Intel[®] 80219 General Purpose PCI Processor

Specification Update

July 2004

Document Number: [274020-002](#)

Figure 2. Intel® 80219 General Purpose PCI Processor P_BMI Signal Implementation for Intel® 80219 General Purpose PCI Processor B-0/B-1 Stepping

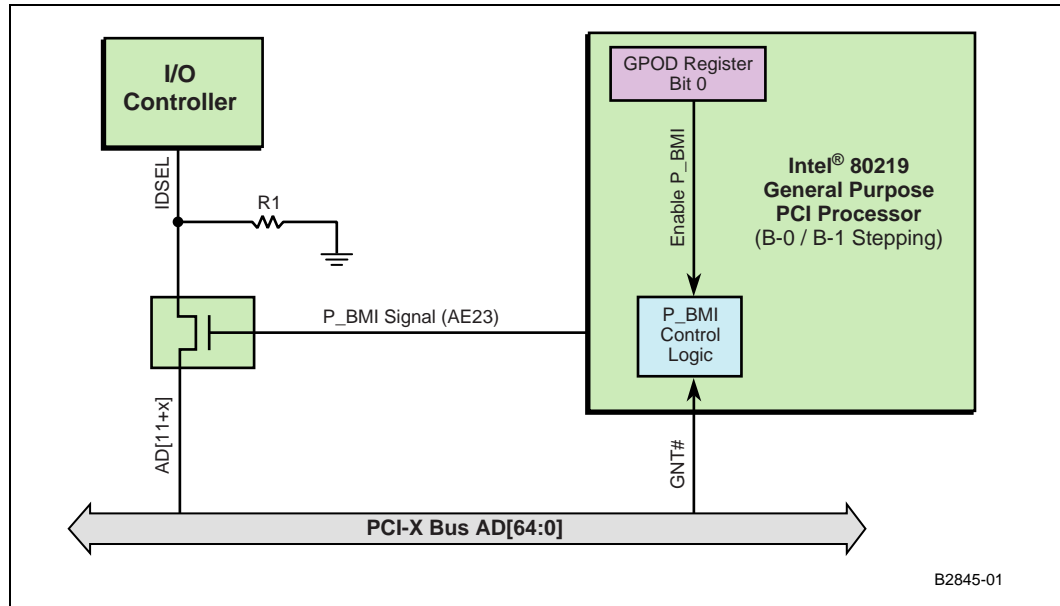
1. Signal NC2 was renamed to P_BMI (AE23). New function added to signal P_BMI.

The P_BMI (AE23) signal has been added to the Intel® 80219 general purpose PCI processor. This signal replaces, using an external GPIO pin for Initialization Device Select (IDSEL) control of an I/O device during host configuration cycles.

The 80219 has eight integrated General Purpose Input Output (GPIO) pins, referred to as GPIO[7:0]. These pins, along with the new PCI-X Bus Master Indicator (P_BMI) signal, can be used to control the IDSEL to the I/O device. External circuitry is no longer required other than a simple switch. The output function of the P_BMI signal is controlled by the GPIO Output Data Register (GPOD), Bit 0 as shown in Table 1. The P_BMI signal is always driven and defaults to driving low at power up.

The IDSEL signal is used as a chip select during configuration cycles initiated by the BIOS, operating system or 80219. The GPOD[0] can be driven low in firmware, thereby disabling the P_BMI signal and hiding the host I/O device from the system, by turning off its IDSEL. When the 80219 intends to perform configuration cycles in the PCI bus segment of the I/O device, the P_BMI signal should be asserted high by driving the GPOD[0] high. The affect of these two operations is, that the I/O device is initialized and controlled by the 80219. More care must be taken with the gate chosen to control IDSEL, since most host bridge controllers do not use PCI address stepping. With IDSEL being a synchronous signal, with respect to CLK, the switch used must be a sub nanosecond propagation delay device (e.g., Pericom PI5C3303). In Figure 2, the P_BMI signal is used to control a MUX/DeMUX switch that is used to enable/disable IDSEL to the I/O device.

Note: The host BIOS does not require any modifications to accommodate this implementation. All the responsibility for I/O device configuration and resource falls to the 80219 firmware.
